1. Changing Description

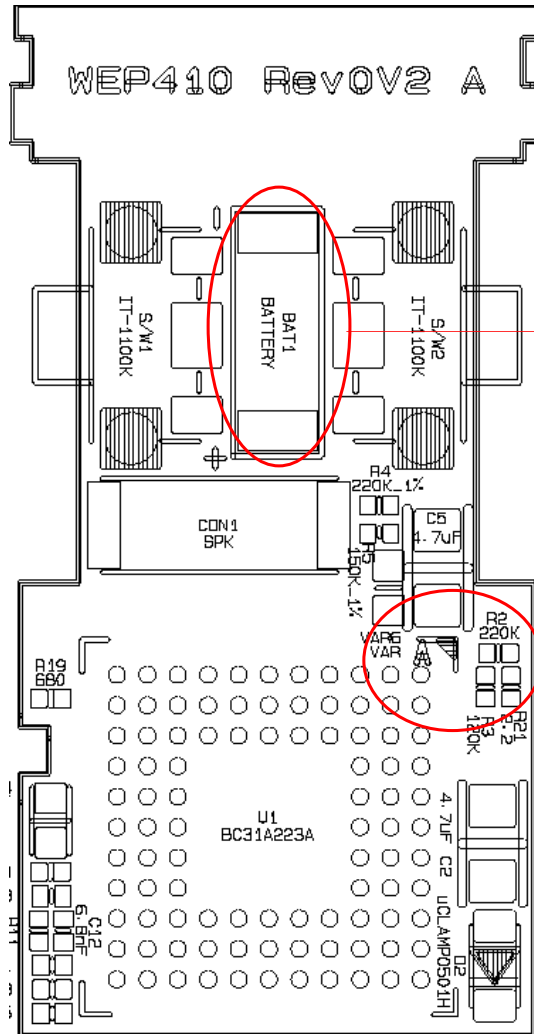
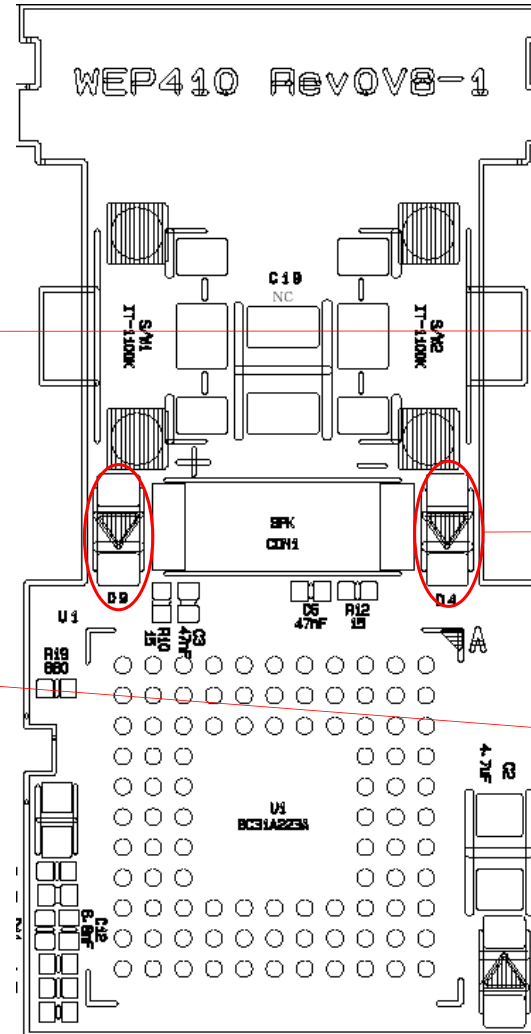
→ Add a ESD Varistor

→ Move position according to changing battery contact type

→ Change battery contact point for easy to assemble (Pad type)

Remove battery connector for easy to assemble

Add ESD diodes

Move position caused by moving speaker connector
